Wollongong Local Planning Panel Assessment Report | 14 September 2021

WLPP No.	Item No. 3
DA No.	DA-2020/1465
Proposal	Mixed use development - construction of a 13 storey residential flat building over a ground level commercial premise and one (1) level of basement parking
Property	15-19 Crown Street Wollongong
Applicant	Traders in Purple
Responsible Team	Development Assessment and Certification - City Centre Team – (BH)
Prior WLPP meeting	Nil

ASSESSMENT REPORT AND RECOMMENDATION

Figure 2 - additional shadow diagrams showing impact on objectors property

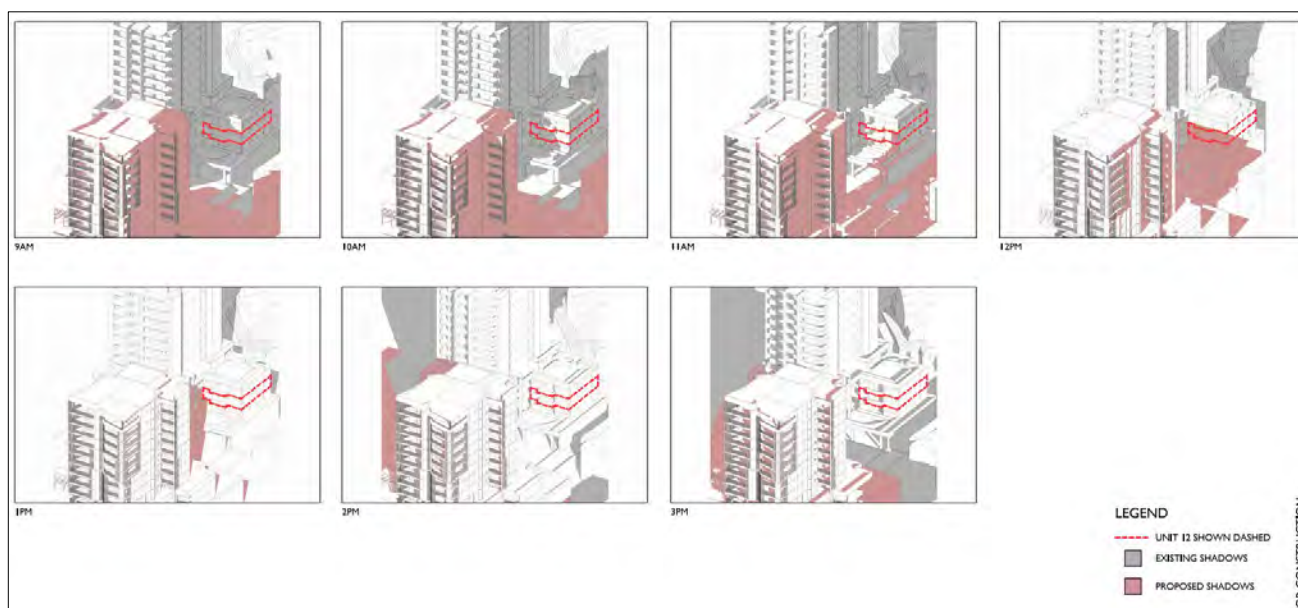
7 View Loss	Some concerns are raised that the height of the building will impact on views. Although the building is significantly higher than the adjacent residential flat building to the west, this site is likely to be redeveloped in the short to medium term and notwithstanding some view loss would be anticipated with any development of this type within the city centre.
8 Tree Planting	One objection raised concern regard the choice of plane trees as street trees. This has been assessed by Council's landscape officer who has raised no concerns. It should be noted that plane trees are a species of tree that exists in this part of Crown Street.

Figure 3 - Site in context of surrounding heritage items

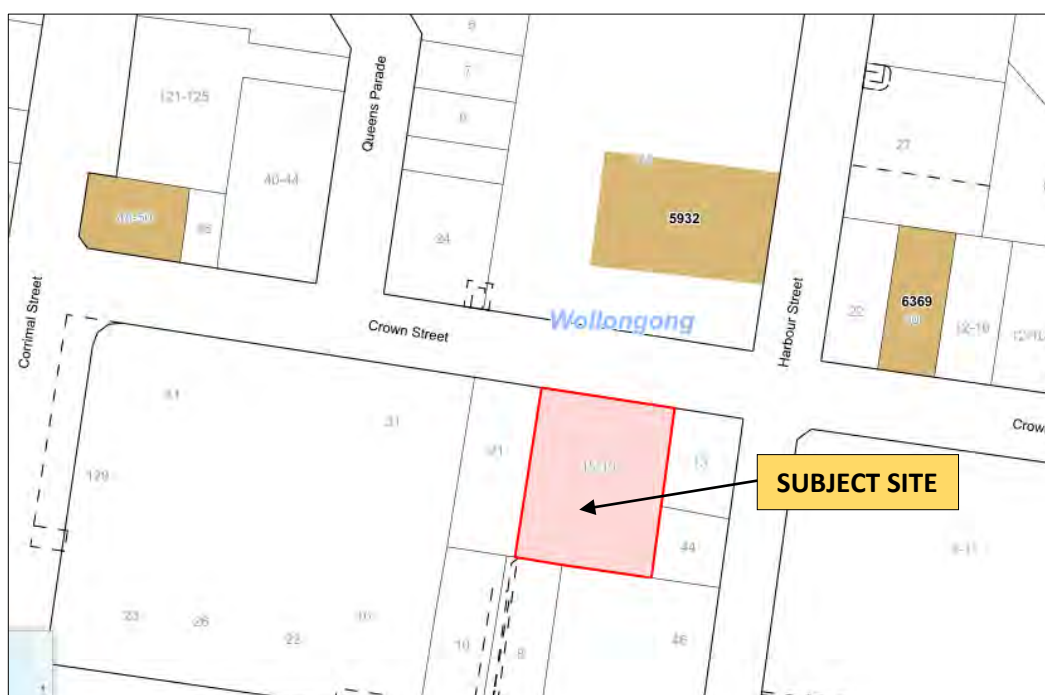
Council has considered Impacts on the adjacent heritage listed buildings. No concerns are have been raised by Council's Heritage Officer in this regard.
